Oakland Planning Commission

STAFF REPORT

Case File Number: PLN14-003-A01 December 3, 2014

Proposal: Appeal of Zoning Administrator's approval of application for

1 SHADOW STUDY 32nd St. 01.2 4 8 LAf N LANDS OF MCELHANEY 530 32nd Street LLC CONDOMINIUM DELVEOPMENT Ad dending and written marchit supporting terms committee and grain and committee and 530 32nd St. Oakland, CA 94609 APN: 9-176-9 tszue/Revision Schedule:

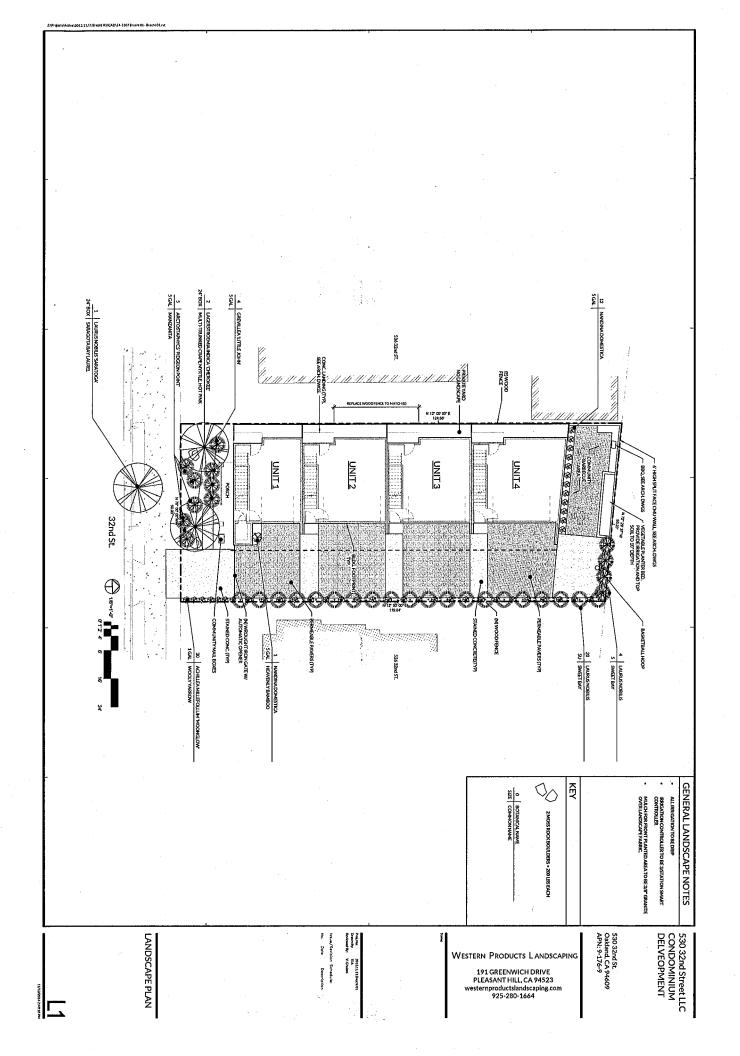
- B) The shadow appears to be quite significant over the eastern bedroom windows and over the planting areas of the yard. We would like to request an animated study so we can assess how the shadow moved over our property over time.

- A) The submitted shadow study is incorrectly labeled as every shadow line is labeled as 9am on the spring fall equinox. Without a properly preparing study, it is not possible to accurately assess the impact of the shadow on our home.
- B) The shadow appears to be quite significant over the eastern bedroom windows and over the planting areas of the yard. We would like to request an animated study so we can assess how the shadow moves over our property over time.
- C) With all units facing east, the adjacent parcel will have a bank of bedroom windows aligned with our existing bedroom windows and directly overlooking our rear yard impact
- D) Since the front doors are facing the side property line, porch lights will also be facing the side property line, resulting is motion lights shining into the bedrooms of our home at night.

- Staff's response: Staff's review of the shadow study prepared by the applicant shows that although there is a mislabeling of the three critical times, the actual shadow analyses were properly done per applicable standards and reveals there are no significant adverse solar impacts on the adjacent property located to the east at 526 32nd Street. The appellant has not submitted any alternative study proving otherwise to support this claim.

- C) Staff's response: Per standard shadow impact criteria, shadow impacts exist when shadow is cast over 50% of an actively used space during at least two of the three critical times (9am, 12 noon, and 3pm) during the Spring and Fall Equinox. In this particular case, shadow is only cast during the 3pm period and there are no shadows whatsoever at 9am or 12 noon. Hence there is no significant shadow impact based on the applicable criteria. With all units facing east, the adjacent parcel will have a bank of

3 WEST ELEVATION

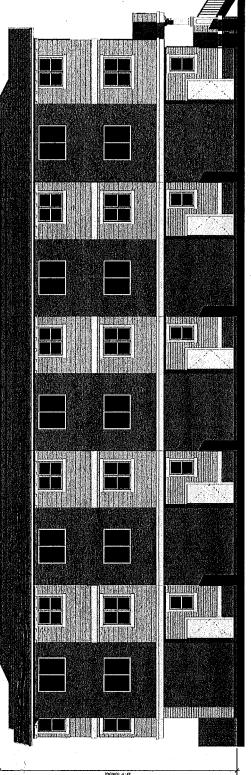
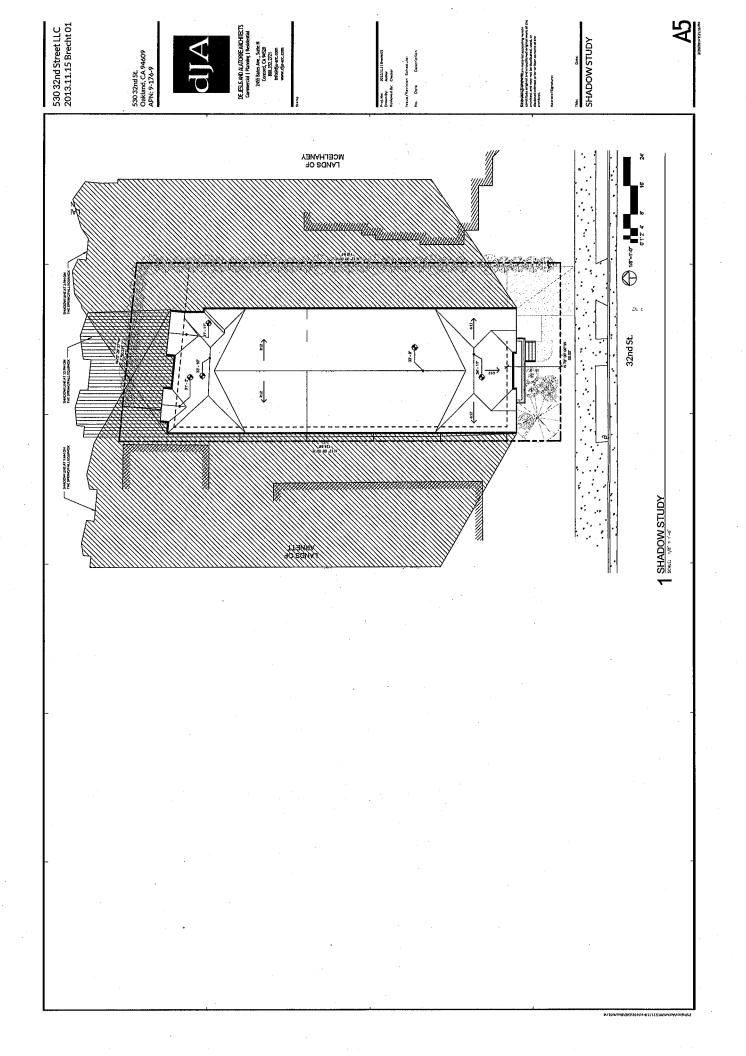
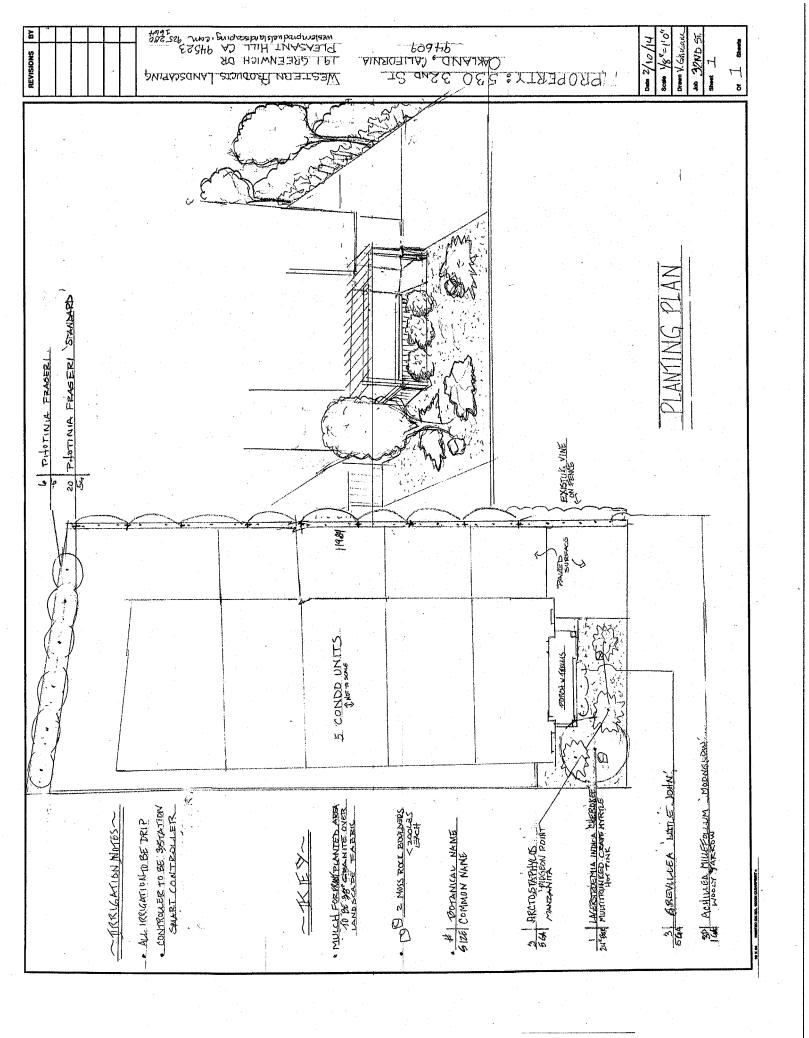
- Staff's response: The street-facing elevations show sufficient real windows (not false) typical of other buildings in the neighborhood. The living room window of the front facing unit faces the street. Since residents are likely to spend more time in the living room or on the street-facing porches on the ground or upper floors, the eyes-on-the-street argument lacks basis.
